WELL TEST ANALYSIS

Company: GMD 3
 Project: 15261 & 15262
 Location: Stanton County

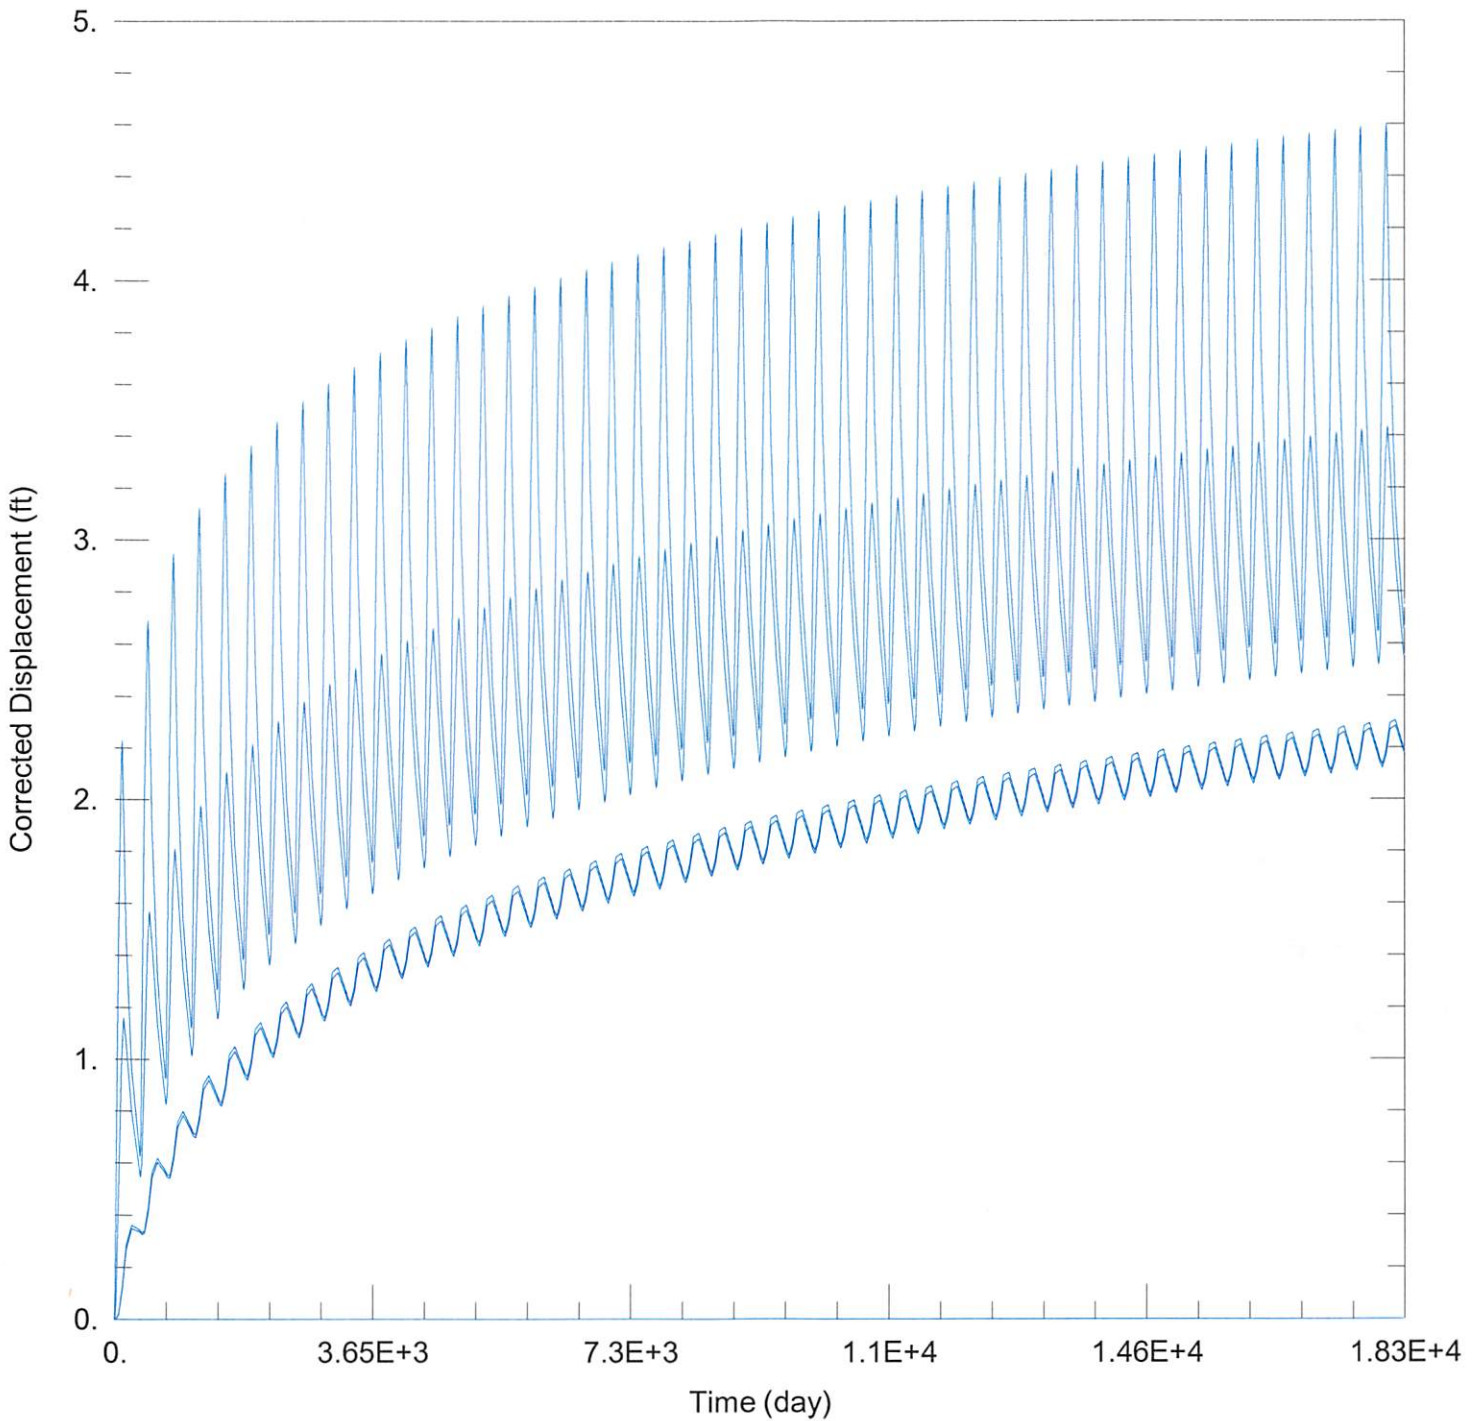
28635: Drawdown from current location = 3.43 ft
Drawdown from proposed location = 4.91 ft
Net drawdown = **1.5 ft**

5195 & 5196: Drawdown from current location = 2.28 ft
Drawdown from proposed location = 3.00 ft
Net drawdown = **0.7 ft**

Domestic 3-30-39: Drawdown from current location = 3.08 ft
Drawdown from proposed location = 3.87 ft
Net drawdown = **0.8 ft**

Net drawdown does not exceed the drawdown allowance of 3.0 ft for any well within 1 mile of the proposed location. Therefore, critical well analysis is not necessary.

The proposed move is likely to create minimal effects on neighboring wells and appears unlikely to cause impairment. Any concerned neighbors should contact GMD3 at (620) 275-7147 or the Division of Water Resources at (620) 276-2901.
